PROLONGED ENGINE CRANK WHILE STARTING (B570)

G30 (5 Series 540d xDrive)

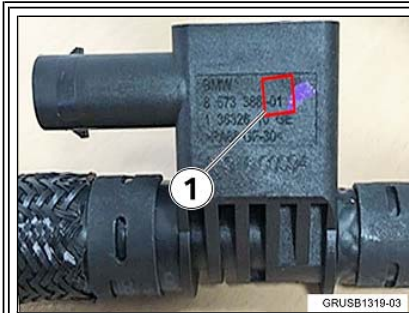
The fuel temperature/pressure sensor of the fuel supply line in the engine compartment is leaking at the connector

As a result, the fuel pre-supply pressure is often “detected” as being too low, even though it is actually within specifications.

The improved fuel line can be determined by the change index (1) and part number located on the fuel temperature/pressure sensor of the fuel supply line.

Sensor part numbers with the improved fuel temperature/pressure sensor, and availability:

- 8 573 386 AI03 as of October 2018
- 8 573 385 AI02 as of January 2019
- 8 591 725 AI02 as of January 2019

Replace the fuel supply line in the engine compartment which contains the integrated fuel temperature/pressure sensor (PN 13 53 8 591 722).

Note: The fuel supply line is located adjacent to the high-pressure fuel pump (1).
